Date: 21<sup>st</sup> October 2019  
Our Ref: JSPE\_255\_L04  
Reg. Ref: W0299-01

**Re: Response to Request for Further Information for development which consists of restoration of part (c. 6.7 ha) of existing quarry (QR19 06/11798 & PL04.225332) by importation of up to 300,000 tonnes per annum of inert soil and stones and river dredging spoil (EWC 17-05-04 and 17-05-06). The proposed soil recovery facility will utilise the permitted quarry infrastructure including internal roads, site office, welfare facilities and other ancillaries to complete the works. Access to the site will be from the permitted main entrance on the N22 National Primary Road. A wheel wash and weighbridge will be provided as part of the proposed development and the existing workshop will be utilised as a quarantine area. A hard-stand with drainage to oil interceptor will also be provided as a designated refuelling area. The total application area including the site infrastructure covers 7.9 ha of lands. The development will be subject to the requirements of the waste management licence. An Environmental Impact Assessment Report (EIAR) will be submitted to the Planning Authority with the application. At: Garry

**Figure 1**

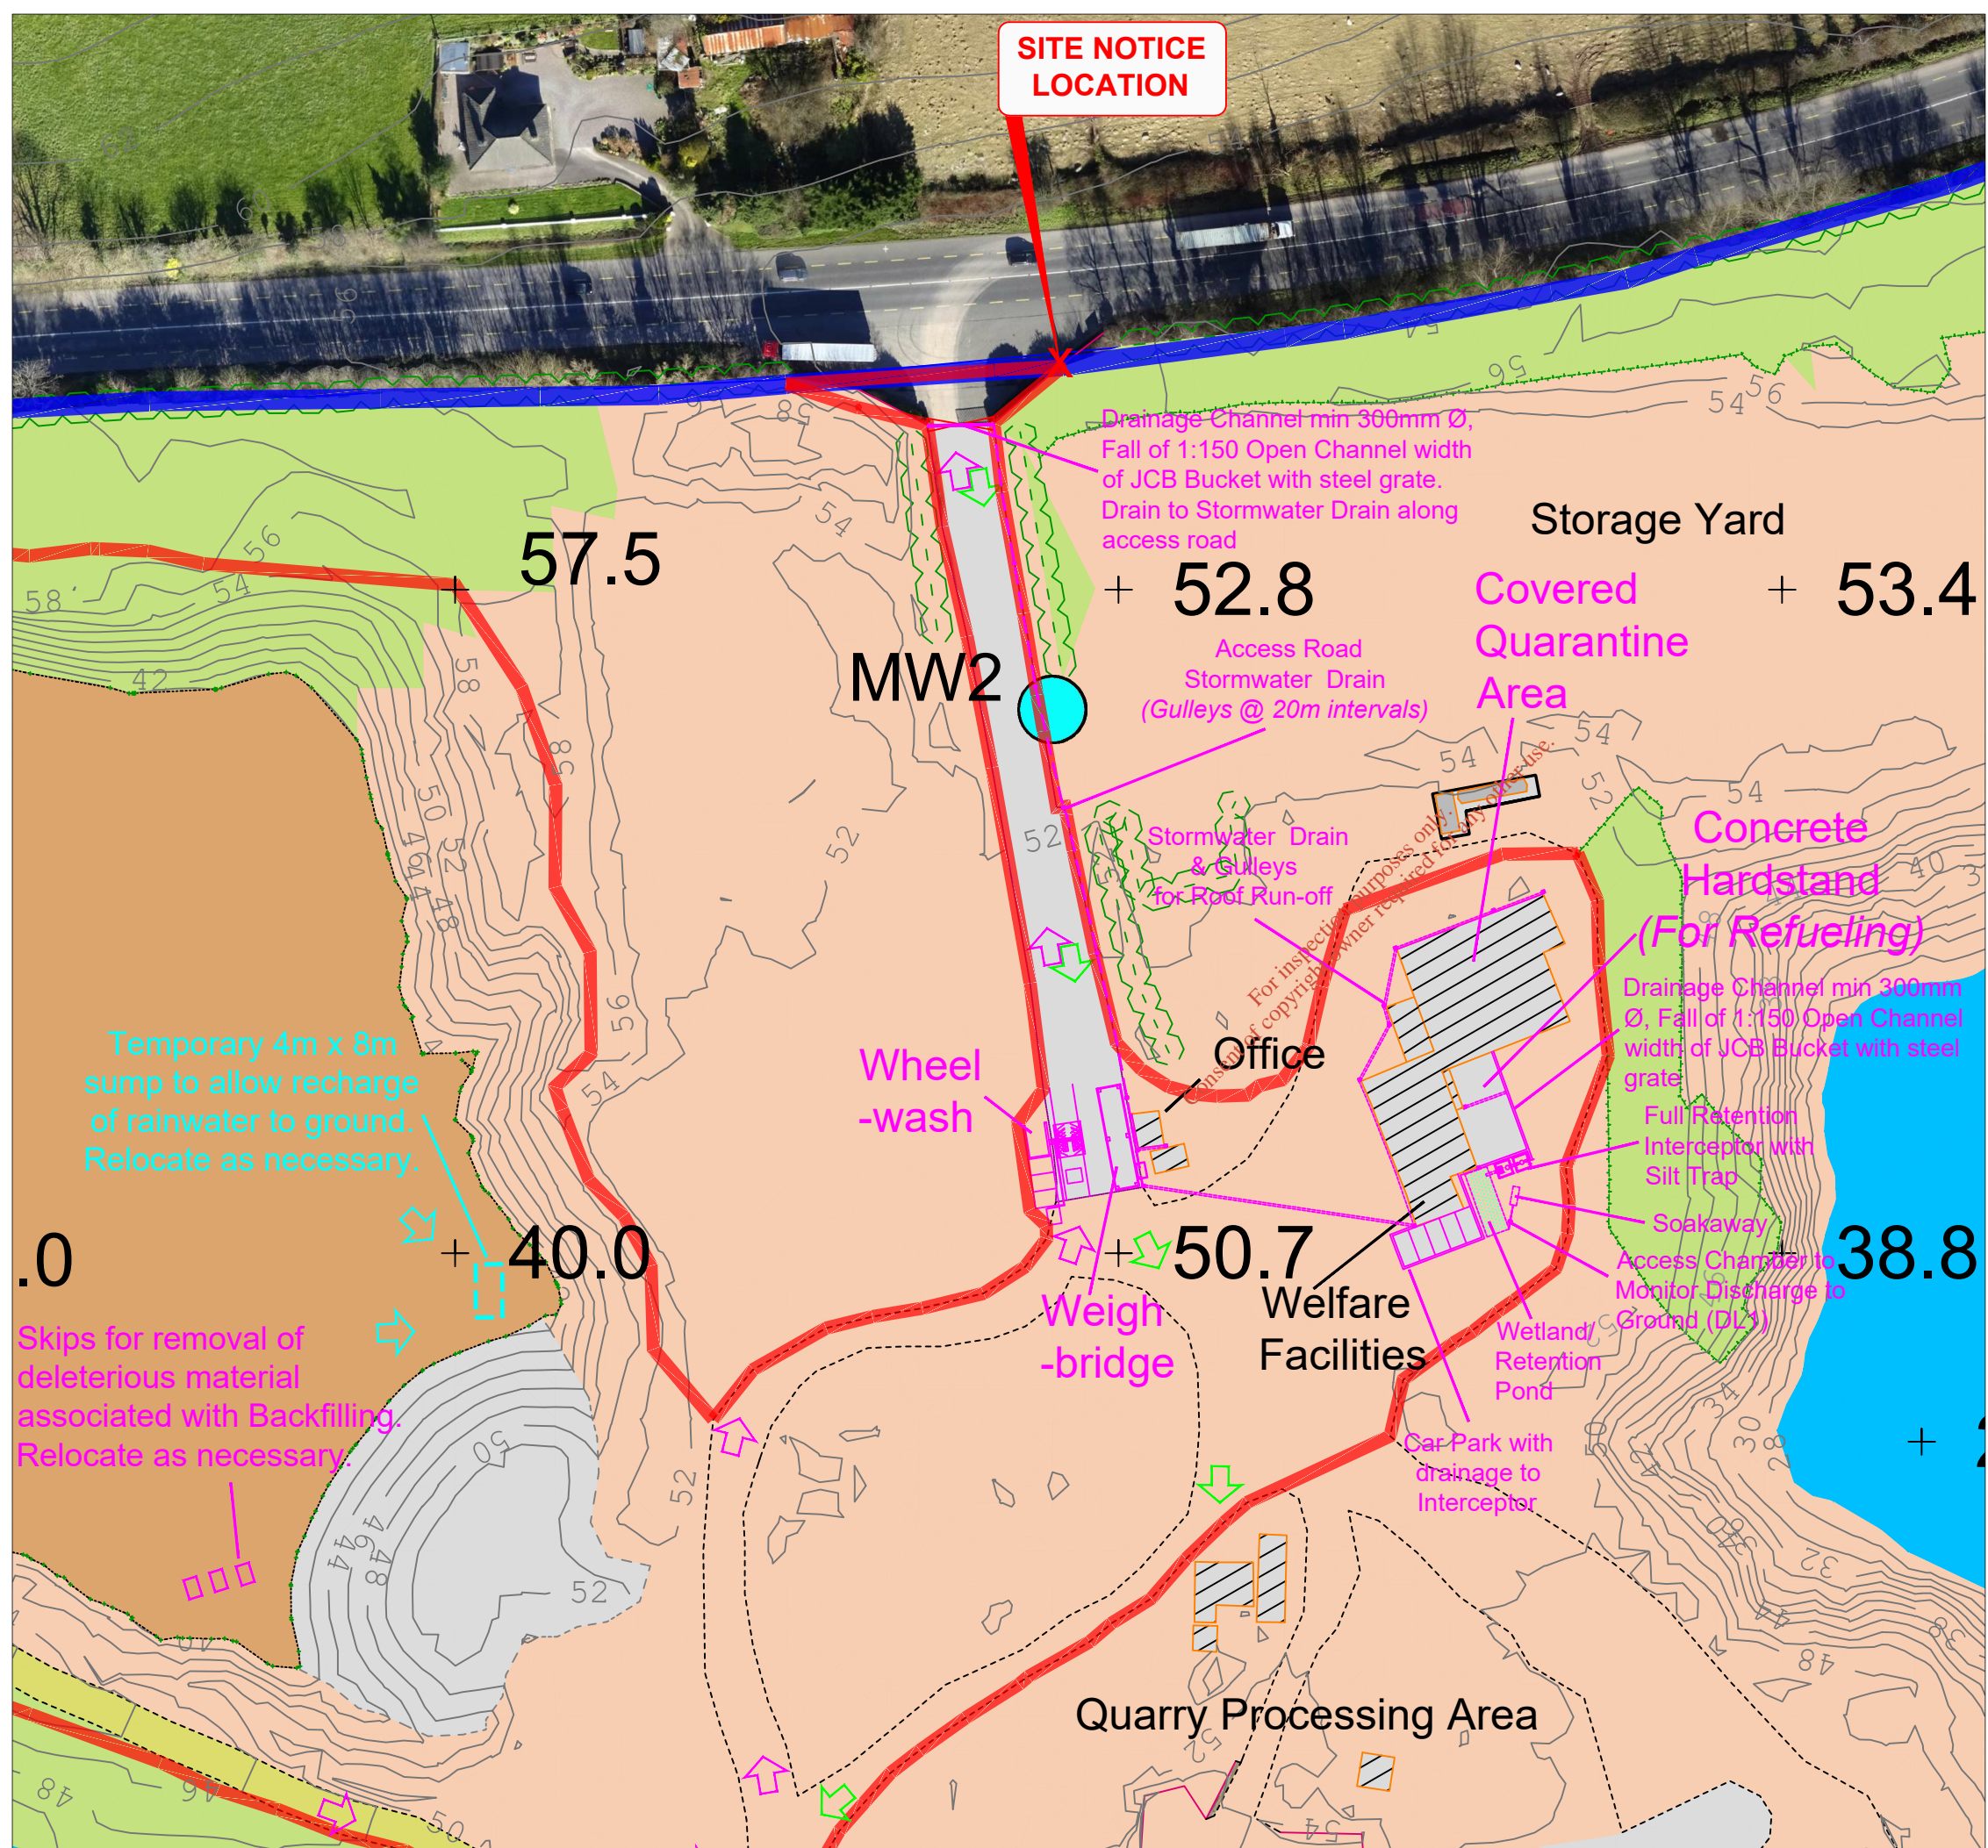
- 1a. Provide a drainage map for the eastern part of the facility showing the entrance road soakaways, stormwater run-off from roofs including discharge point(s), car park and hard-standing areas, silt trap(s) and hydrocarbon interceptor(s) and areas draining to these.

1b. Include in the above or a separate drawing, the stormwater monitoring and discharge point(s) (including six-digit Irish National Grid Reference co-ordinates) for the hydrocarbon interceptor(s).

Site drainage for the eastern part of the facility including entrance road, stormwater run-off from roofs, car park and hard-standing areas, silt trap(s) and hydrocarbon interceptor(s) is shown on the attached Revised Site Layout Infrastructure Plan Drawing D13 Rev 01.

Refer to Revised Site Layout Infrastructure Plan Drawing D13 Rev 01.

A Class 1 Full Retention Interceptor with silt trap is proposed. A detail specification Drawing D08 was submitted with the planning application (P. Reg. No. 18/05155). A copy is included in Appendix IV of Attachment I. Refer also to Revised Site Layout Infrastructure Plan Drawing D13 Rev 01.
